**BEFORE THE WASHINGTON  
UTILITIES AND TRANSPORTATION COMMISSION**

**In the Matter of Avista  
Draft 2021 Electric Integrated Resource  
Plan**

**DOCKET UE-200301**

**COMMISSION STAFF COMMENTS REGARDING  
AVISTA CORPORATION d/b/a AVISTA UTILITIES  
DRAFT INTEGRATED RESOURCE PLANS  
SUBMITTED IN COMPLIANCE WITH  
RCWs 19.405, 19.280 and WACs 480-90-238, 480-100-600 through -630  
AND UNDER CONSOLIDATED DOCKETS UE-191023 AND UE-190698,  
Order R-601**

Figure 2: 2020 Avista Capability and Energy Fuel Mix<sup>19</sup>

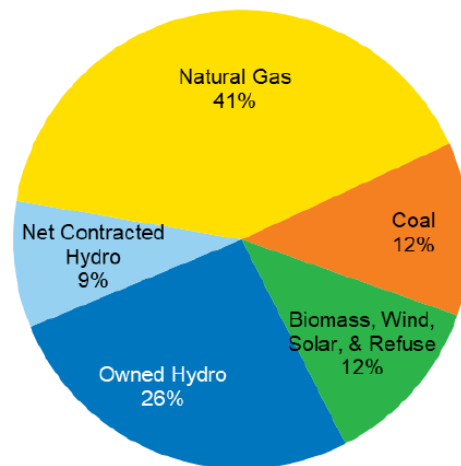
Further, to adequately account for the effect of climate change, Avista could consider acquiring additional expertise regarding temperature impacts over time on Avista’s system, especially considering the company’s hydro-reliance position, as shown in Figure 2. Staff suggests the company take a closer look at the methods peer utilities are taking. For example, Seattle City Light included a study on “Climate Change Effects on Supply and Demand,” as an appendix to its IRP, dedicating resources to assess the IRP climate sensitivity on the utility’s load-resource balance, including reduced snowpack, earlier melt, higher winter inflows, and lower summer inflows. This additional information provided insights into climate change scenarios’ effects to potentially change the *expected base portfolio* for supply and demand.<sup>18</sup>

- Provide discussion regarding the implications of possibly moving from a winter peaking utility to a dual or summer peaking utility.

- Incorporate a suite of variables, including snowpack, streamflow, and rainfall parameters; meteorological trends; and load risks into the analysis. Staff believes further study is needed.
- Consider additional resources, such as a climatologist or climate change specialist, to analyze climate impacts over time on Avista's system.

**Figure 3: Washington Energy Efficiency Avoided Cost<sup>24</sup>**

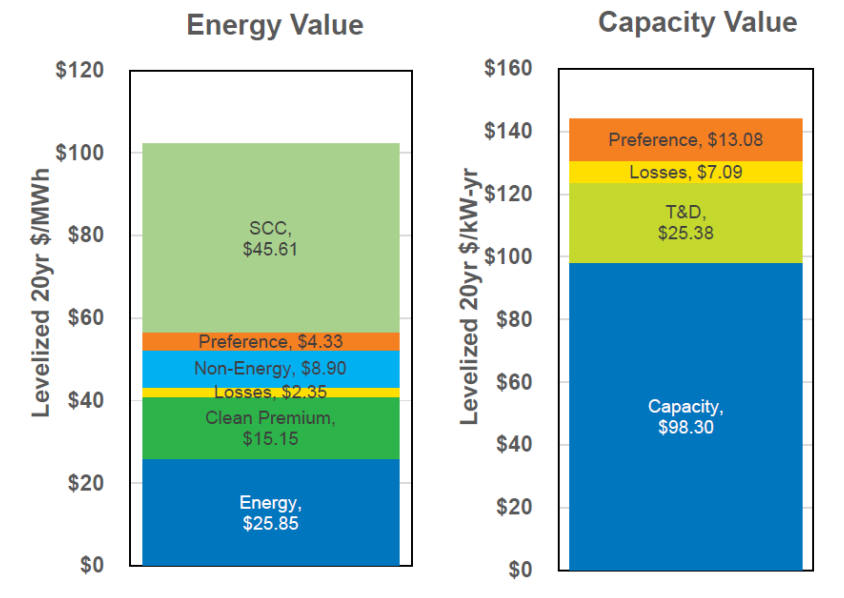
Figure 3 below shows the avoided cost of EE for energy and capacity with components broken out. Over the planning horizon the levelized price of EE is projected to be 3.5 cents per kWh.
